re: **Grading Plan Review**  
**Proposed Residential Development**  
**Wateridge - Block 29 - Wanaki Road - Ottawa**

file: PG4965-MEMO.02

- ❑ Grading and Erosion and Sediment Control Plan, Project No. 119066-00, Drawing No. 119066-GR, Revision 2 dated September 13, 2019.

DRAWING NAME  
**GRADING AND EROSION AND SEDIMENT CONTROL PLAN**

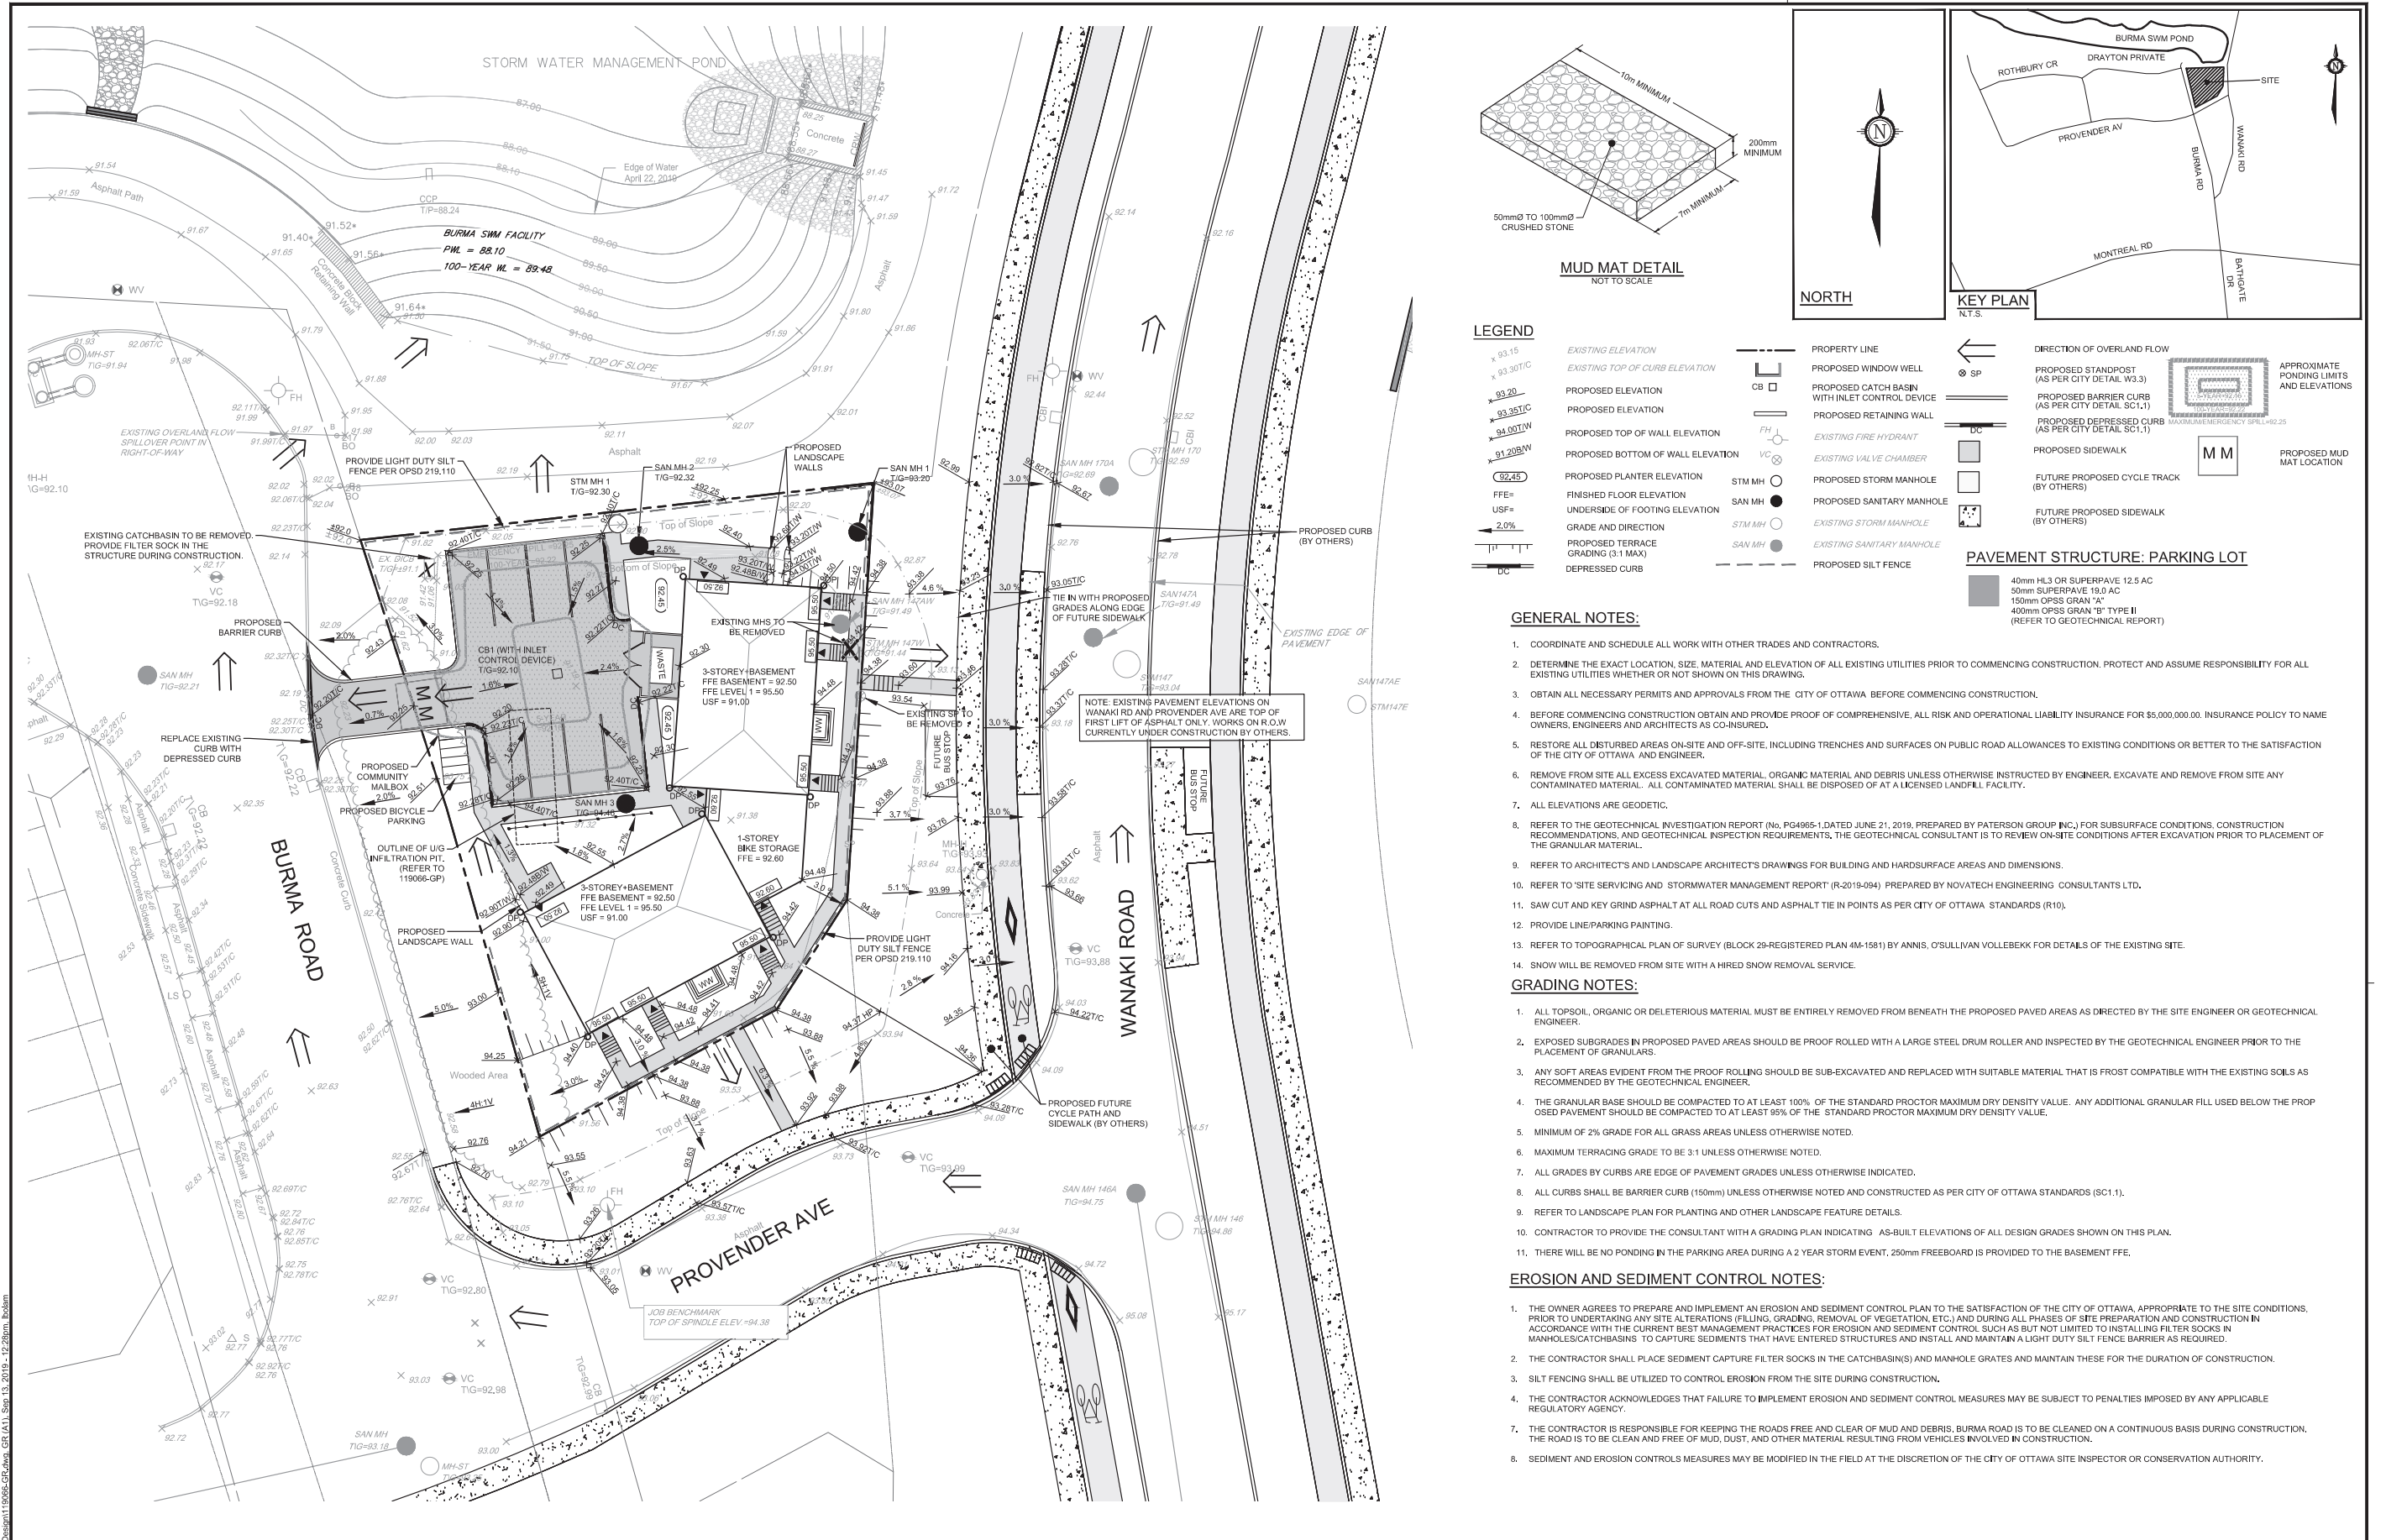
Based on our review of the above noted grading plans, the proposed grade raises for the proposed development of the aforementioned development are generally considered acceptable from a geotechnical perspective.

For design purposes, pad footings up to 5 m wide, and strip footings up to 3 m wide, placed on an undisturbed, hard to very stiff silty clay bearing surface designed using a bearing resistance value at serviceability limit states (SLS) of **150 kPa** and a factored bearing resistance value at ultimate limit states (ULS) of **225 kPa** is considered acceptable from a geotechnical perspective for the proposed buildings.

Furthermore, footings placed on an approved fill bearing surface can be designed using a bearing resistance value at SLS of **100 kPa** and a factored bearing resistance value at ULS of **175 kPa**. A geotechnical resistance factor of 0.5 was applied to the above noted bearing resistance values at ULS.

Footings designed with the provided bearing resistance value at SLS should have a total and differential settlement of 25 and 20 mm, respectively.

The bearing surface should be verified at the time of construction on a lot by lot basis to determine the appropriate serviceability resistance value.
